Product Change Notification
Quark Carrier for NVIDIA® Jetson Modules

PCN Number:	CTIU-00045
Revision:	0.00
Issue Date:	2022-04-25
Effective Date:	2022-04-25

NGX004	NGX014

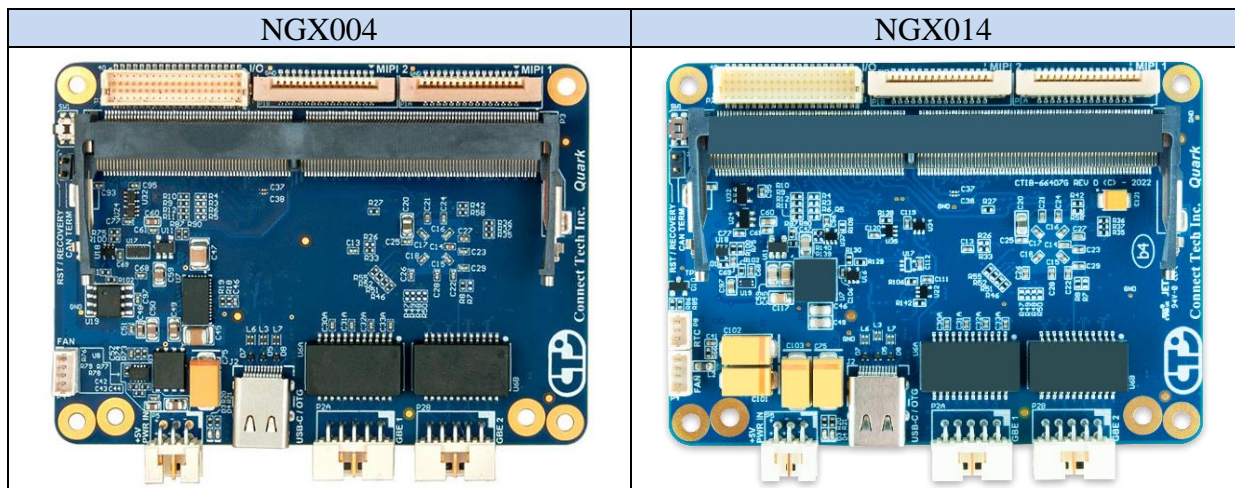
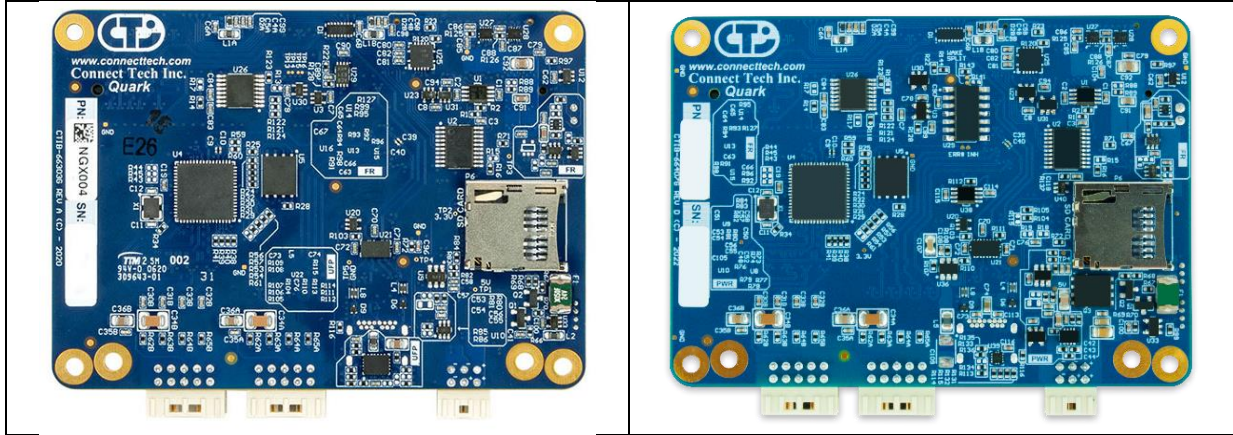
Carriers with alternative parts (NGX014), when used with BSP version XAVIER-NX-32.7.1-V001 or older, will have a limited advertised current capacity on the USB Type-C port as shown below.

The NGX014 is fit, form, and function compatible with the NGX004, with the exception of the advertised USB current capacity as noted in the software compatibility section.
